STARTER KIT (GR26099)

**MODELS : G260PUM/G260PUH
G231PUM/G231PUH**

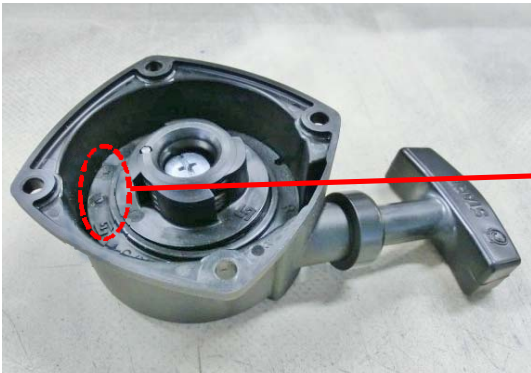
Recently, we found that there was a wrong part in the Starter Kit (GR26099). They were made on March 11th in 2014. The Reel in the Recoil was different from standard.

Please check the stamp on the Reel. If you found the stamp number "40311", please let us know. We would like to exchange to the correct Recoil (848ESZ7510). With the wrong part, the dumper spring may be bent and it makes hard to start.

Please check the stamp on the Reel in the Recoil.

If the stamp is "40311", that is with wrong part.
If the other numbers, they are the O.K.
